TSB01082015

## TECHNICAL SERVICE BULLETIN

Models: Traditional BR Harvesters

**SUBJECT: Conveyor Motor Failure**

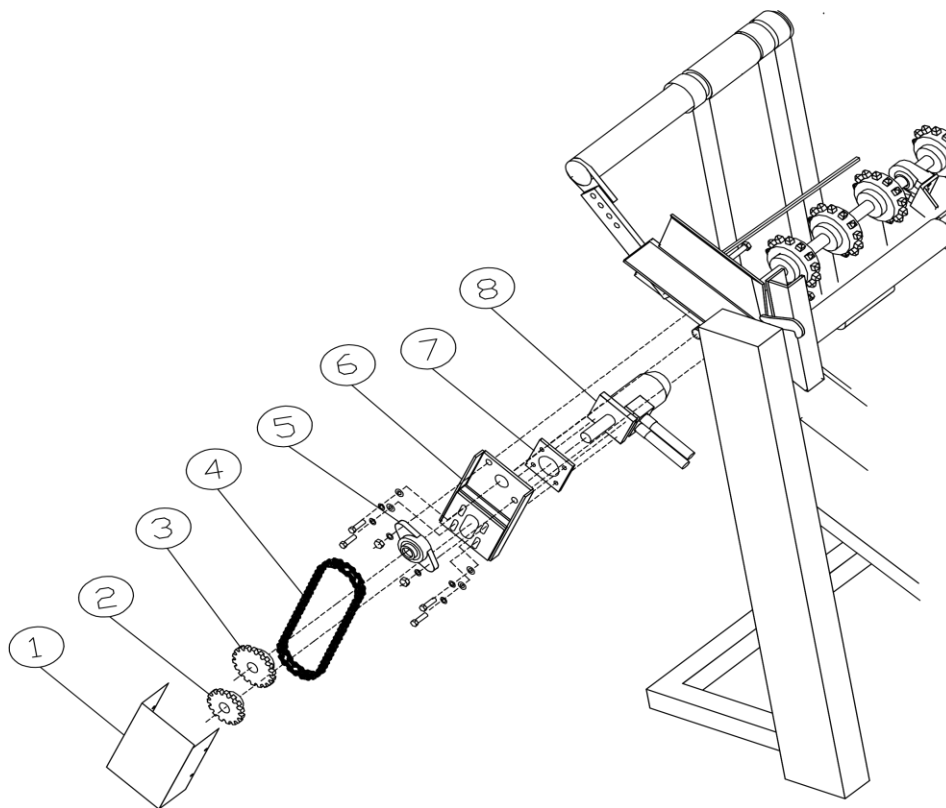
When replacing the front or rear conveyor drive motor on a BR model harvester, be certain that the motor spacer (7) is correctly installed between the motor and motor mount bracket (6). See above drawing.

If the spacer is not located between the motor and mount bracket, the shaft-end cap on the motor will crack when the motor mounting fasteners are tightened.

If the motor end cap is cracked, the motor will leak a substantial amount of hydraulic fluid. The leakage generally appears to be leaking from the motor shaft seal.

It is important to note that the motor spacer may remain on the hydraulic motor when the motor is removed from the mount bracket. **Do not discard the spacer.**

When installing the motor, tighten the motor fasteners in a crossing pattern, in several steps, to 25-30 ft.-lbs. (34-41 N.m).
